WEST SUSSEX COUNTY COUNCIL CONSULTATION

TO:	Arun District Council FAO: Amber Willard
FROM:	WSSC – Highways Authority
DATE:	17 June 2026
LOCATION:	Land rear of Meadow Way Westergate
SUBJECT:	AL/35/26/RES Approval of reserved matters following outline consent AL/178/22/OUT for appearance, landscaping, layout and scale for the construction of 89 No residential dwellings, together with open space, landscaping and associated infrastructure, with access taken from Meadow Way (resubmission following AL/137/24/RES). This application is a Departure from the Development Plan and is in CIL Zone 3 and is CIL Liable as new dwellings.
DATE OF SITE VISIT:	n/a
RECOMMENDATION:	More information

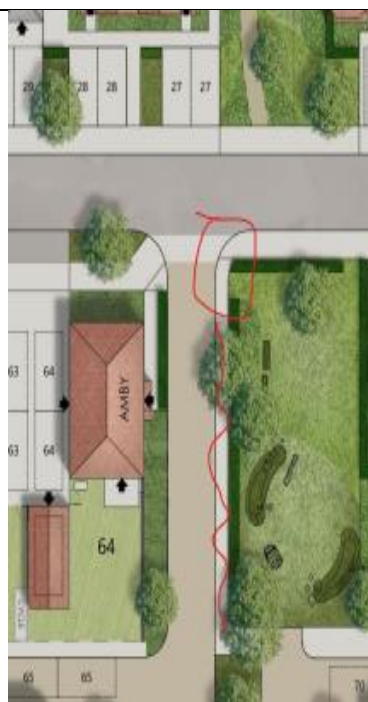
Terminating at the parking space or grass verge. This will cause tripping hazards or safety issues and conflict with moving vehicles. Inconsistent use of materials makes it unclear if it is a shared surface or carriageway with footway.

Site Layout Plan (SL.01 REVA) shows the following areas that need to be re-considered. They should be providing a clear detailed transition from tarmac footway, extending past any granite sets dropping the pedestrian into a shared surface (usually block paving). The differentiation between footway surfacing and shared use surfacing and levels needs to be clear and consistent.

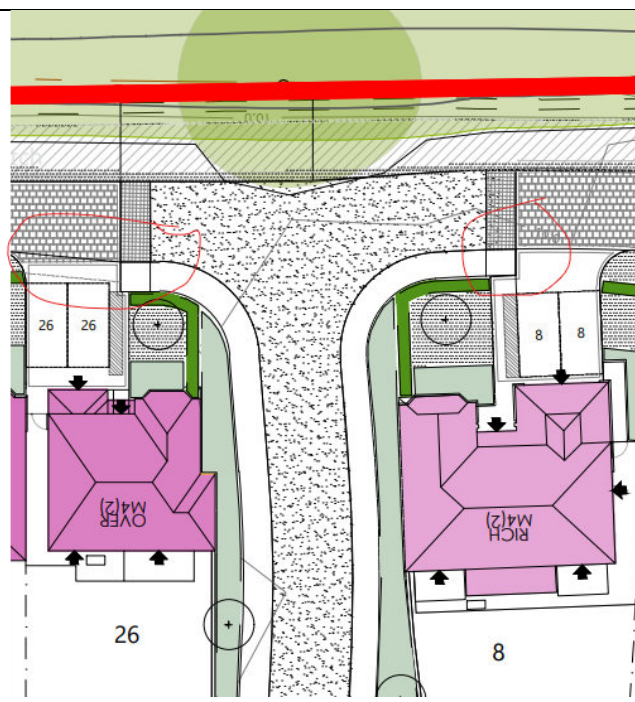
Doesn't drop a pedestrian into the shared space behind granite set.

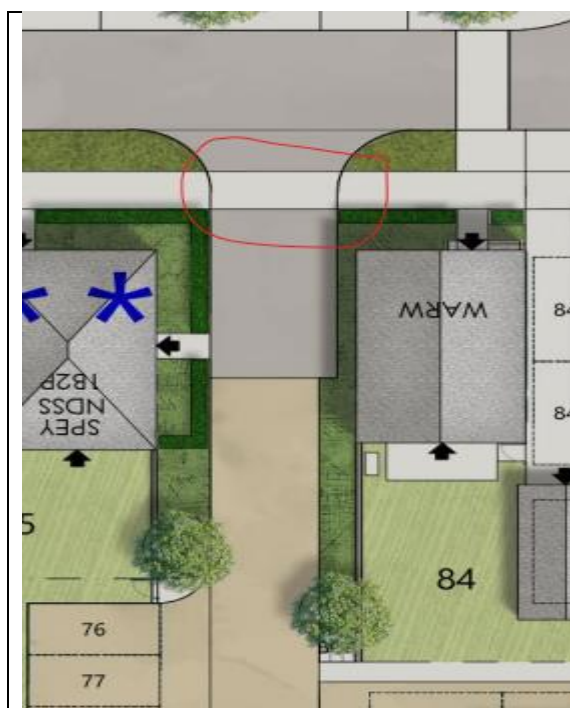
Doesn't drop a pedestrian into the shared space behind granite set. Also, directs a pedestrian into a parking space.

Whilst this gives the pedestrians priority it doesn't drop a pedestrian into the shared space to the south. Materials used tarmac/block paving just changes	How does a pedestrian with visual or mobility impairment follow the footway into the shared space? Why is a different surface material used outside of the shared space? What appears to be the turning area.
---	---
